Record of Executive Business and Chief Executive's Order

Reg. Reference: SD22B/0058 **Application Date:** 11-Feb-2022
Submission Type: Additional **Registration Date:** 12-Jul-2022
Information

Proposed Development: (a) The removal of the existing conservatory and the construction of a new 20.5sq.m single storey kitchen; (b) the removal of existing shed to the side of the house and construction of a new 17sq.m boot/utility room; (c) extend the lounge forward into existing porch area, 5.2sq.m with rooflight over; (d) extension of 7.9sq.m to the existing family room/den to the side elevation, south; (e) detached 25sq.m shed in the rear garden. At first floor level: (f) the construction of a new stairs and stair well to the front elevation to roof level with an apex roof and new windows, 4.5sq.m; (g) extension to bedroom 3 on south elevation of 6.3sq.m along with layout changes to all floor levels along with elevational changes to dwelling; (h) removing existing roof and chimney and replacing it with a new roof to include 2 dormer windows, one to the front elevation and one to the rear elevation, clad seamed aluminium and 2 'Velux' windows to the rear elevation and providing a new st

Roads Related Additional Information Requested by SDCC:

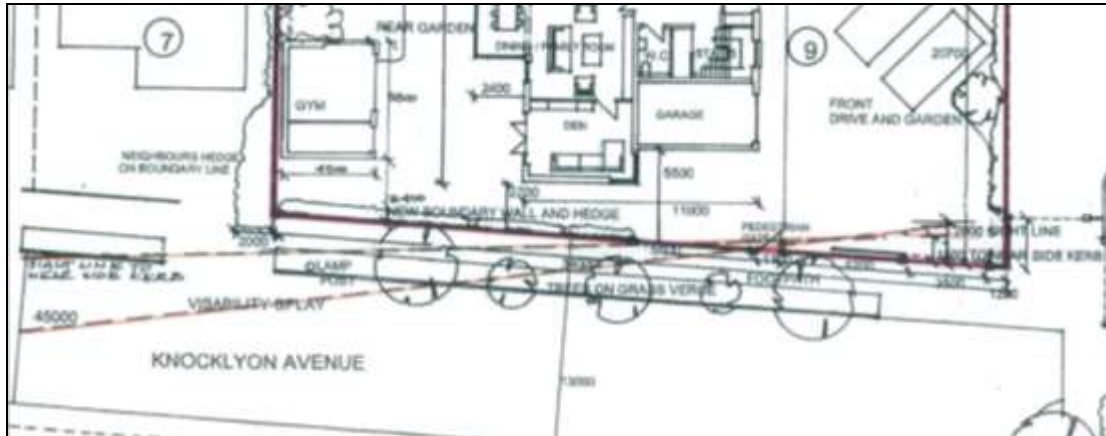
1.(a) The applicant is requested to submit accurate plans demonstrating the provision of a visibility splay of 2.0m x 45m to the west of the entrance. Sightlines should be shown to the near side edge of the road to the right hand side of the entrance (when exiting). This will determine the length of front boundary wall that must be limited to a height of 0.9m in order to improve forward visibility for vehicles. It is noted that the 45m comes from Table 4.2 (Forward Visibility) of DMURS (Design Manual for Urban Roads & Streets) and the 2m comes from Section 4.4.5 (Visibility Splays) of DMURS. Figure 4.63 of DMURS also explains the dimensions.

The submitted visibility splay shows two separate sightlines. The required sightline should be taken from a distance 2m back from the edge of the public footpath and extend 45m to the nearside kerb. The submitted drawing shows the sightline to the nearside kerb is only taken from a distance 1.5m back from the edge of the public footpath. This should be amended in order to determine the length of the 0.9m high boundary wall which is required to achieve adequate visibility.
